6/7/2007 – 8M000070 GM C4500/5500 4x2 Suspension

To: UltraRide® Suspension Dealers

Summary of Service Issue

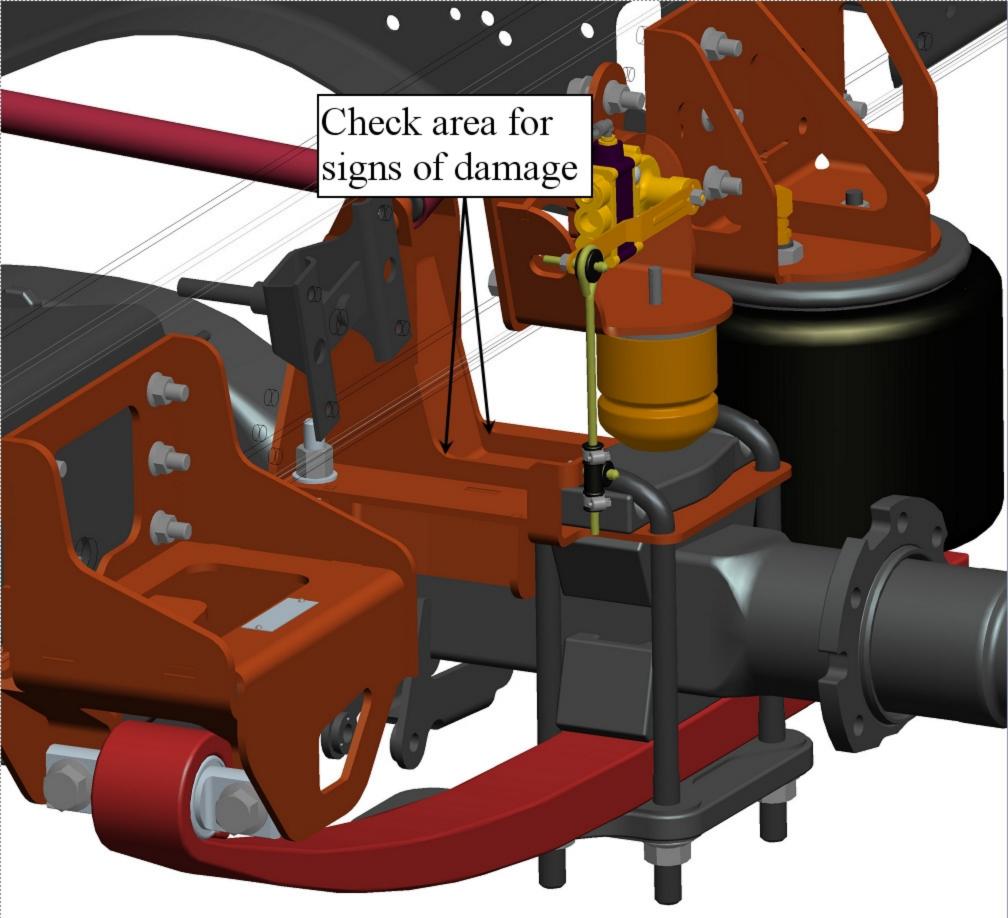
Recently a small number of field failures have been reported on **ambulances and buses** relative to the lateral control rod bracket of the GM C4500/5500 4x2 UltraRide® suspension, part number 8M000070. Specifically, the lateral control rod bracket out of the axle kit for the 13.5K GM C4500/5500 4x2 suspension, part number **8M000072**, has developed cracks in these reported failures. As a result, Link Manufacturing, Ltd has made a running change to this lateral control rod bracket. The axle kit part number for the GM C4500/5500 4x2 13.5K suspension is now 8M000092.

This is a safety related concern and should be addressed with a high degree of urgency. If not corrected, this failure could result in a loss of vehicle control. All ambulance and bus applications must replace their lateral control rod bracket with the new bracket kit, part number 800M1041.

- 2) Provide Link with a list of all customers, including VIN number and contact information.
- 3)**Perform** an **inspection** of the lateral control rod bracket. A picture showing where to inspect is attached.
- 4) **If cracks are found, remove the vehicle from service immediately!** Call Dan Dykstra or myself at **1-800-222-6283**.
- 5)The lateral control rod bracket must be replaced on all ambulances and bus applications. Call us to order the new bracket kit, part number 800M1041. At that time, a labor allowance and labor rate will be discussed and approved by Link.
